PROCLAMATION CALLING A SPECIAL MEETING OF THE BERKELEY CITY COUNCIL

Thursday, July 23, 2020

title sheet number NEW ELEVATIONS

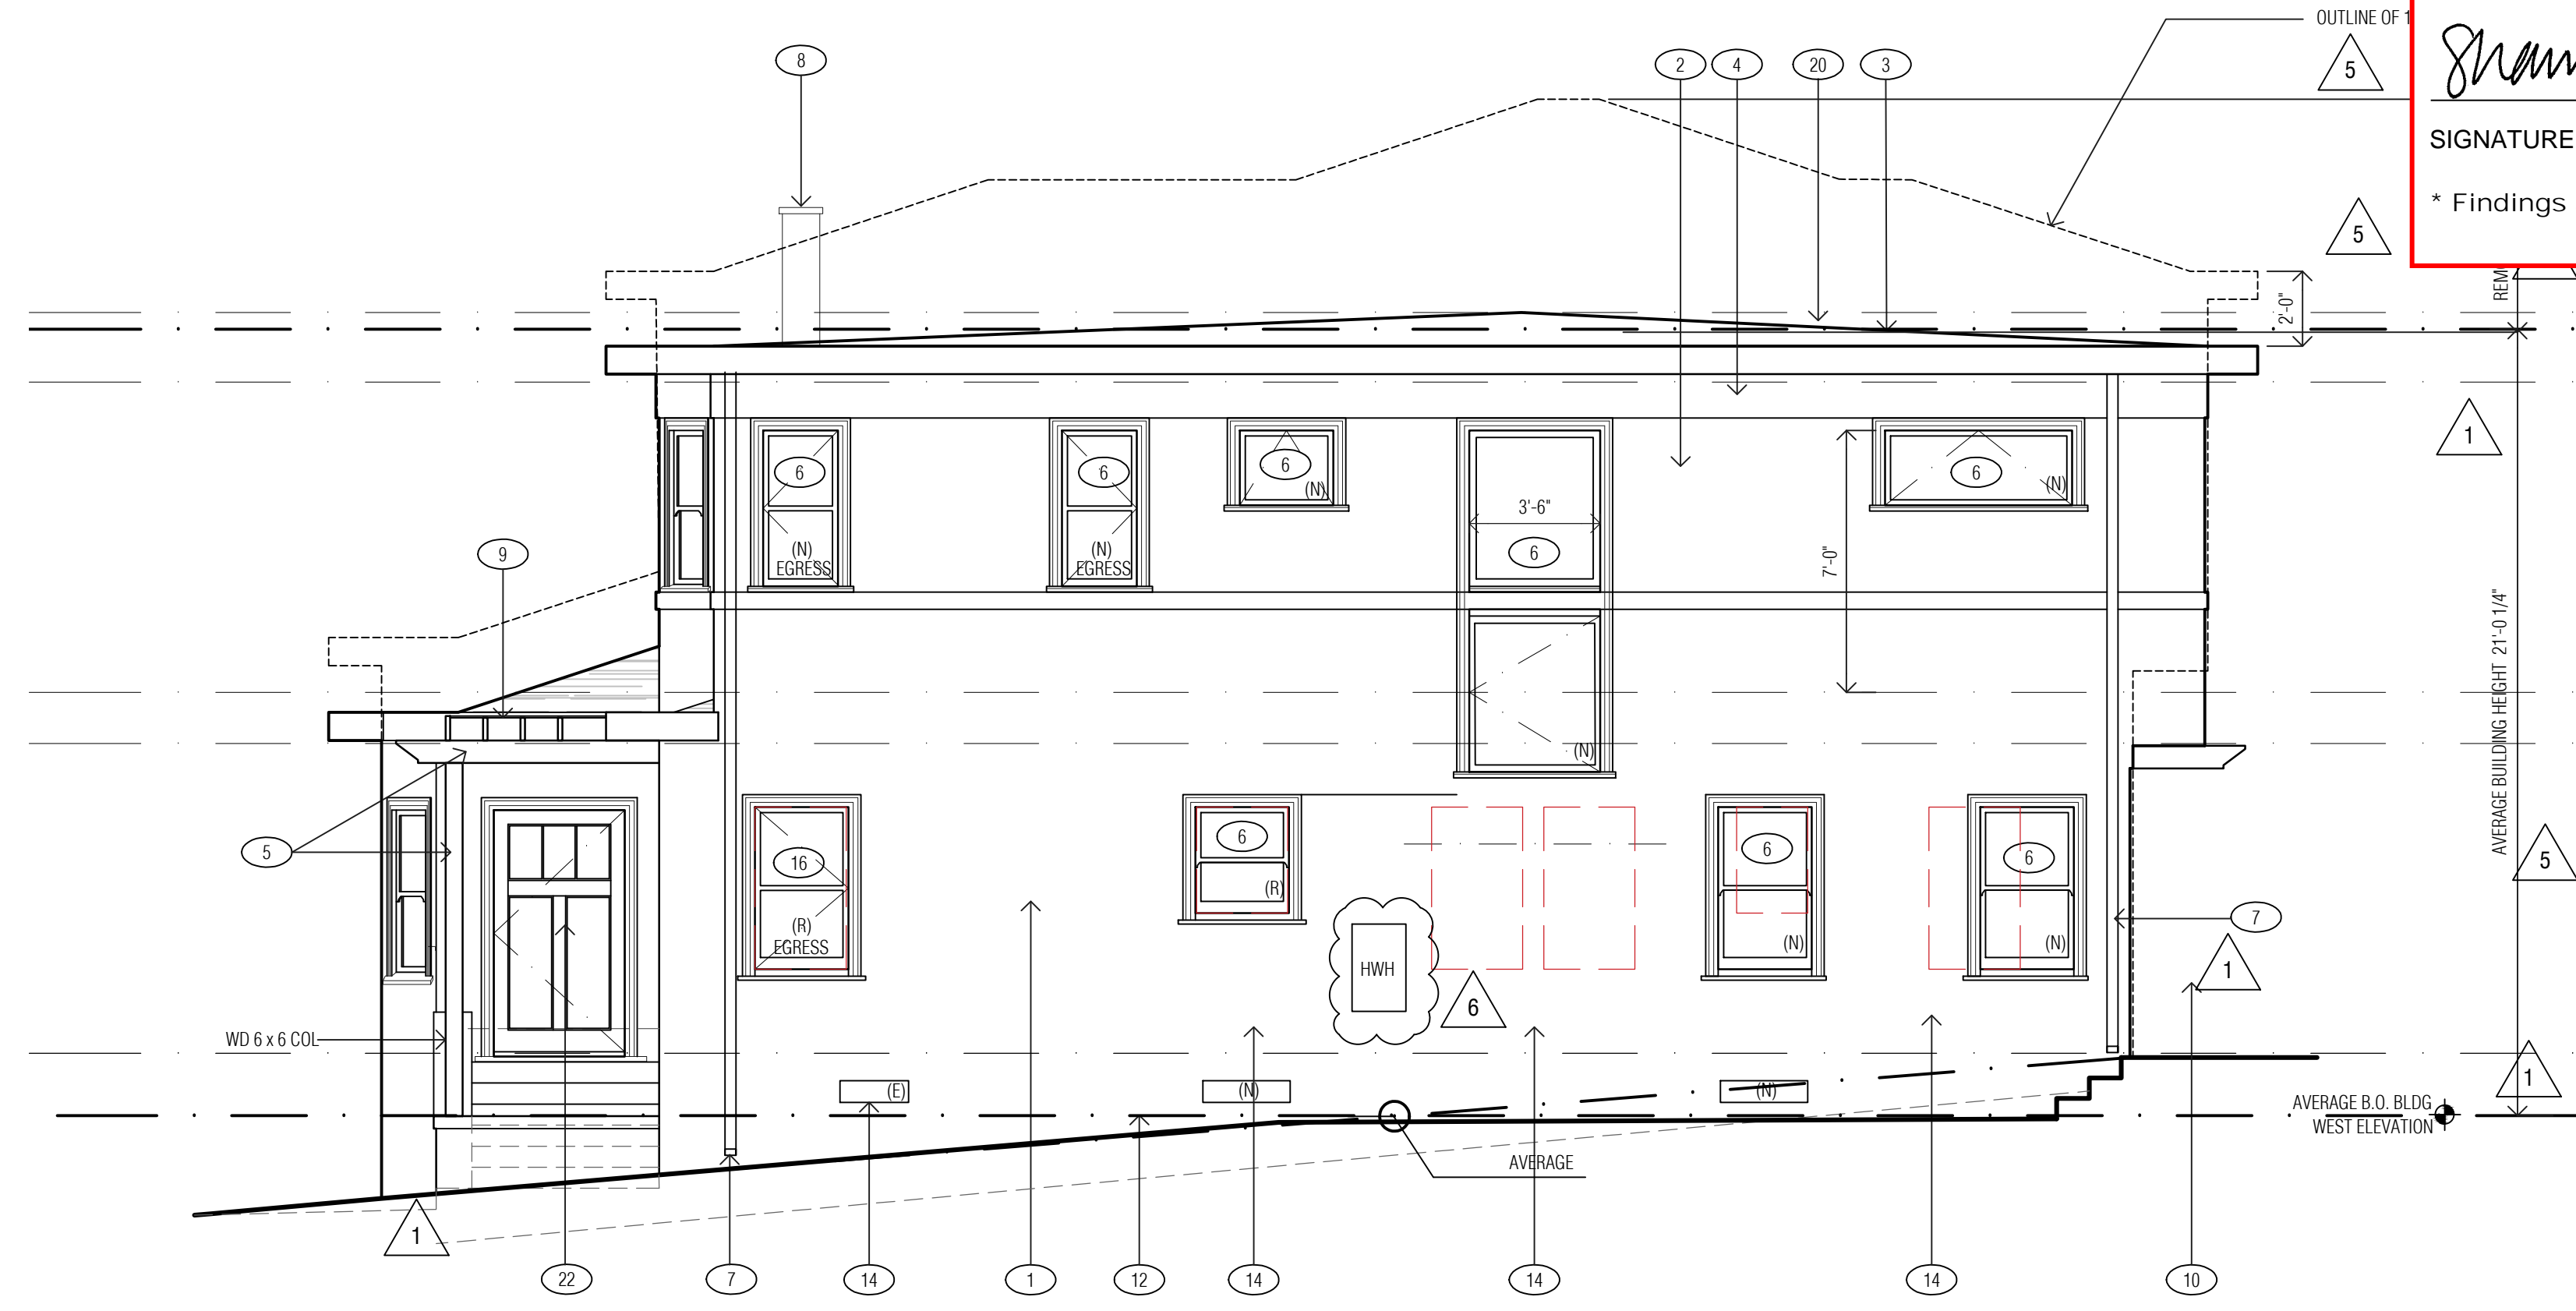
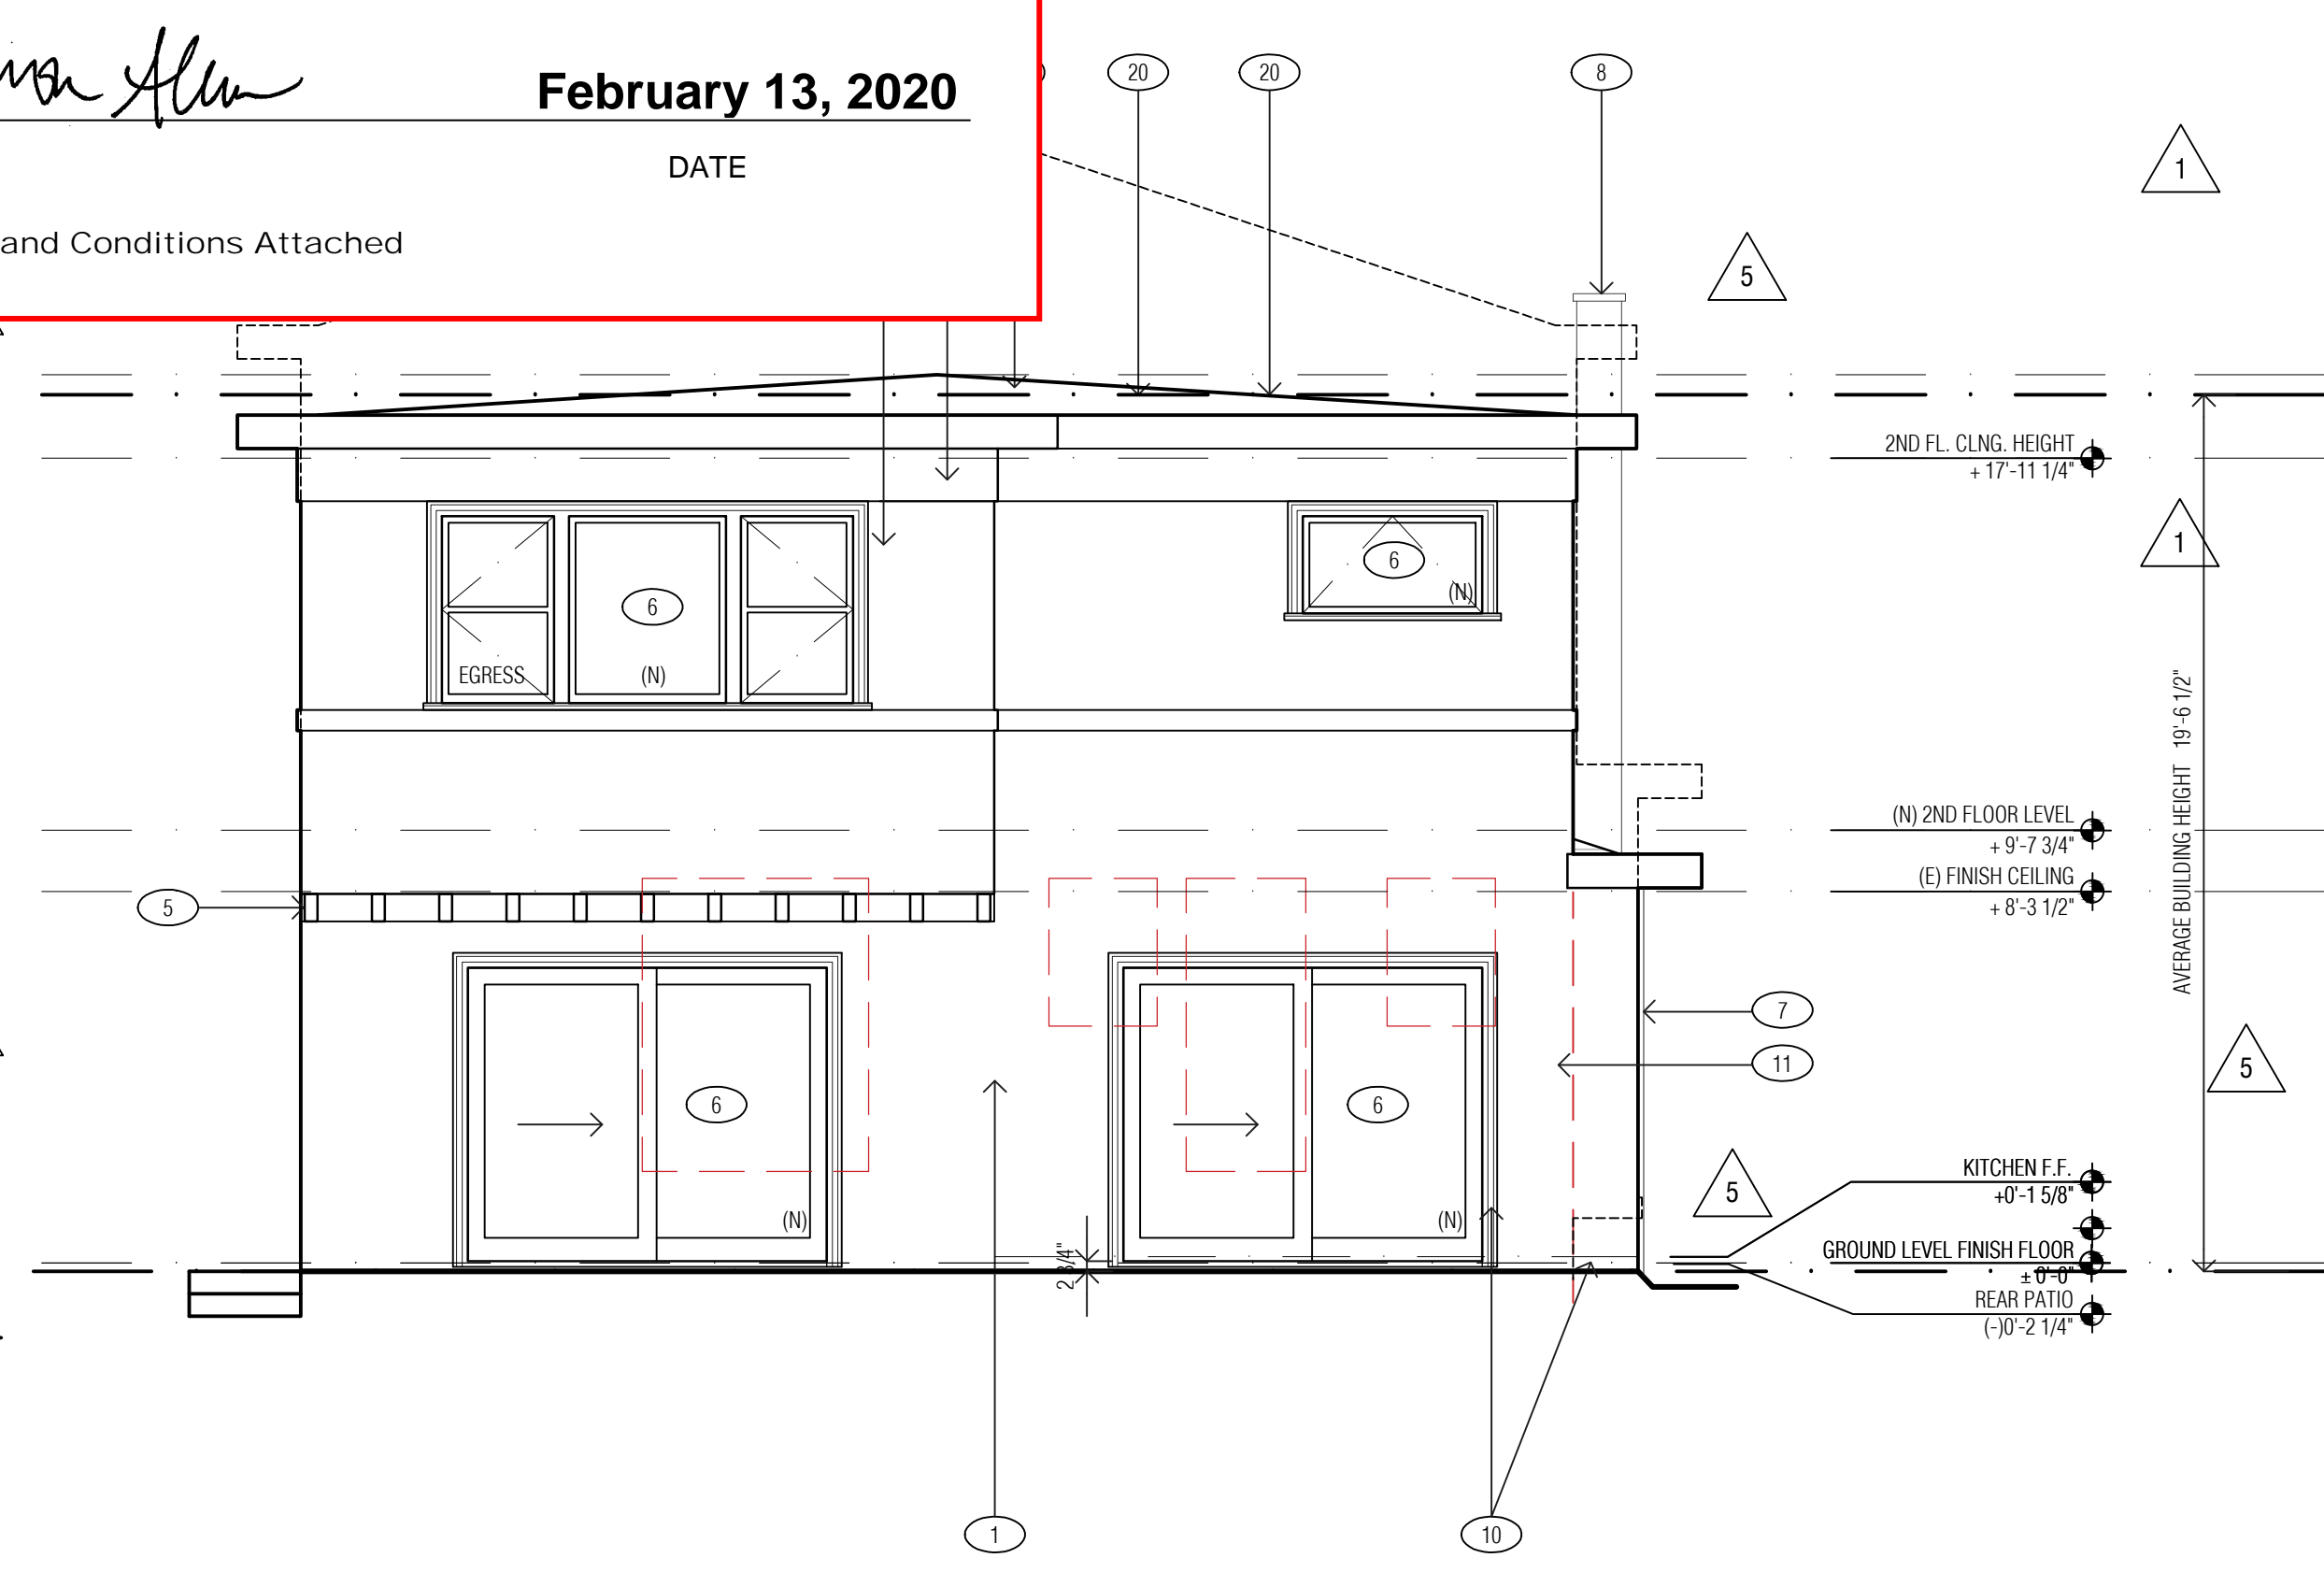
Response 2: The applicant revised the project at the direction of staff to lower the building height, by redesigning from a pitched roof design to an essentially flat roof and lowering the ceiling height of the second floor in such a way that the average height of the roof was reduced from 27 feet 1 ¼ inches to 23 feet 7 ½ inches (as shown in the south elevation on sheet A3.1 of the plans received June 10, 2020, Attachment 5).

On drawing A3.1 Eisenmann Architecture's current design shows the top of roof height at the east elevation to be 19'-9.5" from the average bottom of building. At the south elevation, that same dimension is 19'-6.75".
